ARB SUBMITTAL

CITY OF PALO ALTO

PUBLIC SAFETY BUILDING

CALIFORNIA AVE. PARKING GARAGE

ARB COMMENTS AND RESPONSES

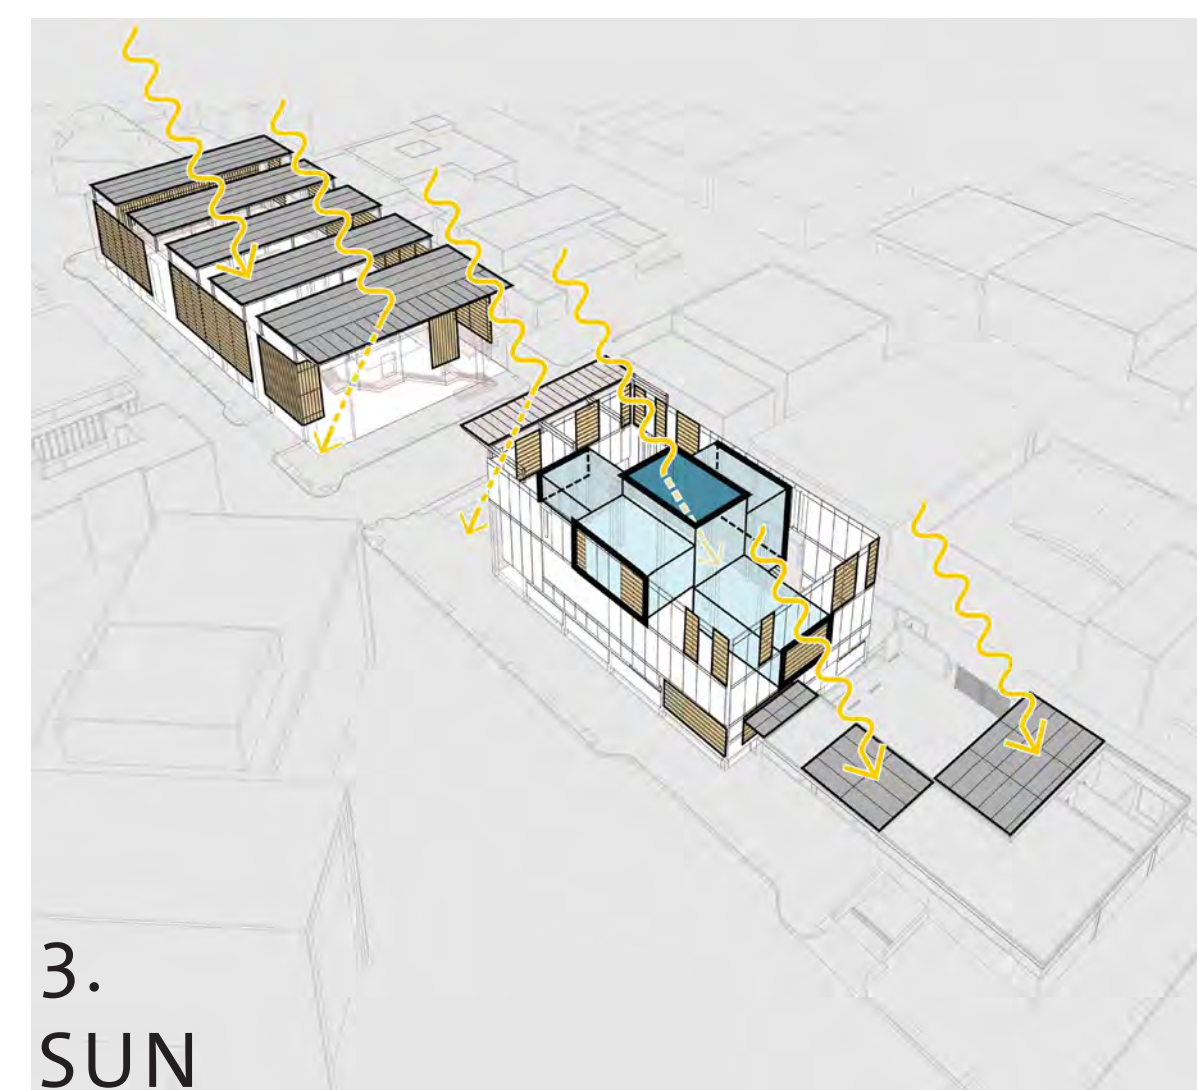
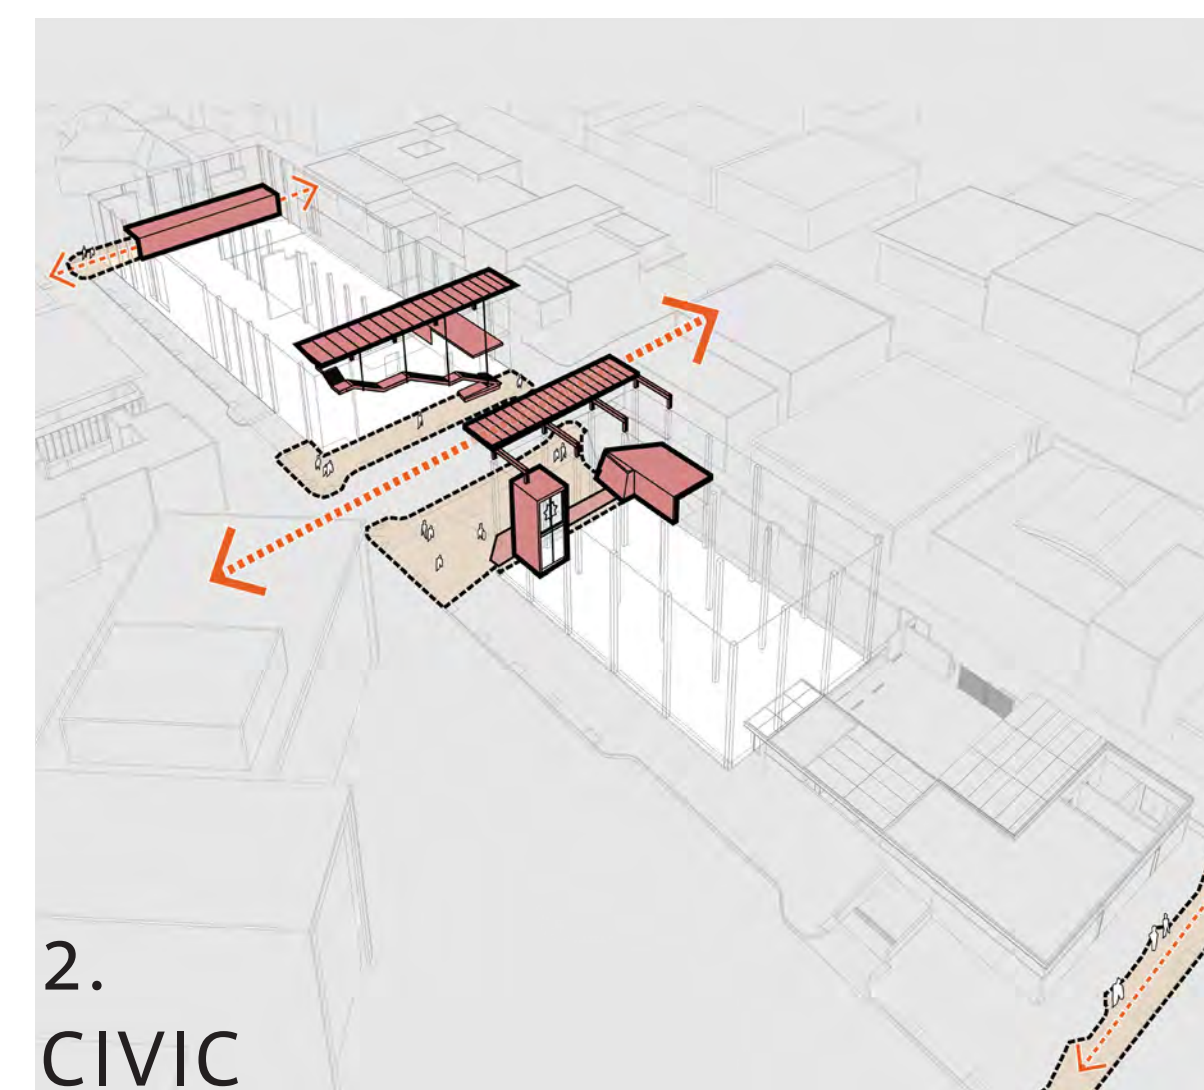
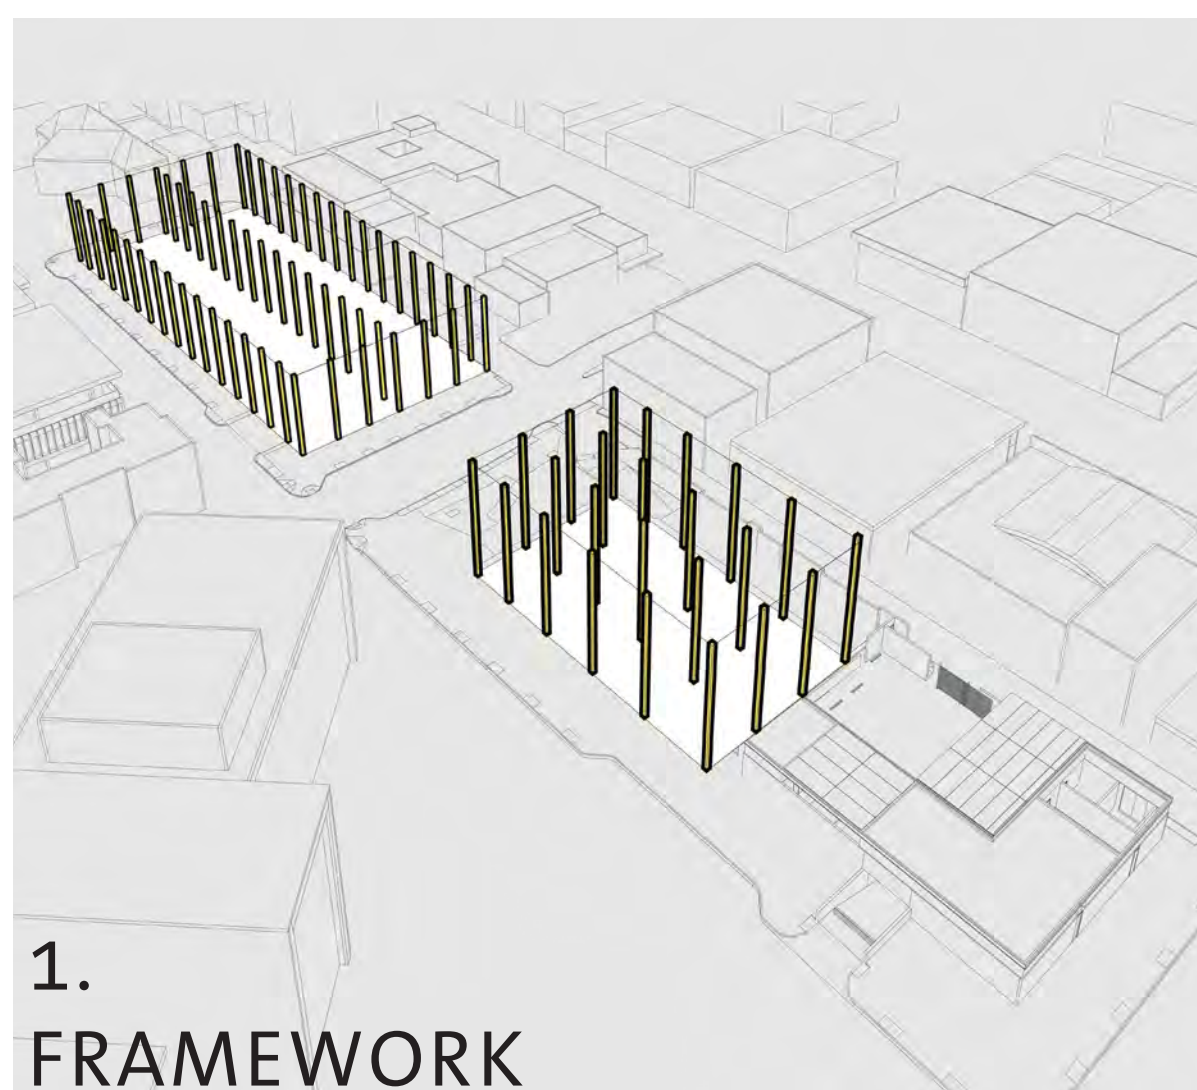
#	Comments	Response	Action Taken
Board Member #1			
1.01	Police yard may end up being a mess, and a lot of buildings look down on it. Would like utilitarian functions moved underground.	<i>Information:</i> Of the 12 vehicle stalls currently shown in the at-grade parking court, all but one are oversized vehicles that cannot be moved into the basement due to height and turning radius clearances (a standard minimum ADA head clearance requirement is 8'6"; some of the larger vehicles are up to 13'-0" tall). One is an ADA stall which may (or may not) be able to be removed pending code review.	Mitigating measures have been incorporated to address the concerns voiced, including: 1. A large overhead canopy covers 50% of the vehicles and screens the operational courtyard from view from the top floors of the adjacent residential project 2. The perimeter site wall will be finished in the same high-quality materials used on the building. Will read more like "courtyard walls" than like site fencing. 3. New trees are planted in the operational courtyard, providing additional attractive screening, and added benefit of making it feel like a landscaped courtyard. The status of the ADA stall is pending.

1.02	All three options currently look like bunkers. Of the three, this board member prefers Scheme #2 as a starting point...appreciates the dynamic massing. "If you're going to go out there, why not."	<i>Agreed. some dynamic composition will add visual interest</i> <i>Agreed. bunker look not appropriate.</i>	The <i>dynamic massing</i> approach appears in the current proposal as a series of civic "points of contact," dynamic design elements that create visual variety and interest.

#	Comments	Response	Action Taken
Board Member #2			
2.01	Don't think that the two buildings should look the same. Garage is not a civic building, PSB should be more special.	<i>Agreed. The PSB should have greater civic prominence.</i> <i>Consideration: Though not a civic building per se, the civic aspects of the parking garage may be elevated over civic opportunities, and could tie together the public functions over the two blocks.</i>	As a strategy to enliven the perimeter of the parking garage, civic elements—a grand staircase, two pedestrian arcades—utilize a common "civic language" evident through the project. Beyond this, the garage is given a reduced prominence relative to the PSB.

2.02	Remove the ramp that connects to Birch Street. Grossly inappropriate. Agrees that pedestrian movement is north/south in this area, "not a place to have a police car coming in and out."	<i>Operational Consideration: One purpose of having two ramps is to offer an alternative means of patrol egress should the primary ramp (at the street onto which the ramp opens) become unusable. This may be due to flood, fire, explosion, active shooter, etc. By moving the secondary ramp to the same street as the primary ramp, this neutralizes this operational benefit.</i> <i>Park Blvd. is not recommended as an alternative exit point as this is a bicycle boulevard.</i> <i>It is the PD's preference to retain the Birch Street ramp in its current location, but for the design team to provide mitigating measures to make its presence acceptable.</i>	1. To avoid traffic impacts, the garage entry is right-in/right-out only. No vehicles will cross Birch. 2. The ramp is for personal vehicles only; patrol vehicles will not use this ramp on a day-to-day basis. 3. Design mitigations are provided to screen the ramp, and provide an amenity to the plaza.

2.08	Parking garage: soften the edges, give some insets. Small plaza. Not a civic building, so make the edges more user friendly.	<i>Agreed. The edges of the parking structure offer the greatest opportunity for providing civic richness.</i>	1. Large civic, grand staircase added to east side of parking structure. 2. Pedestrian arcade is articulated on the west side of parking structure 3. Pedestrian arcade added to connect NE garage entry to mid-block passage across Jacaranda 4. Garage designed with re-entrant corners. The recesses provide visual breathing room, will be accommodated with landscaping.
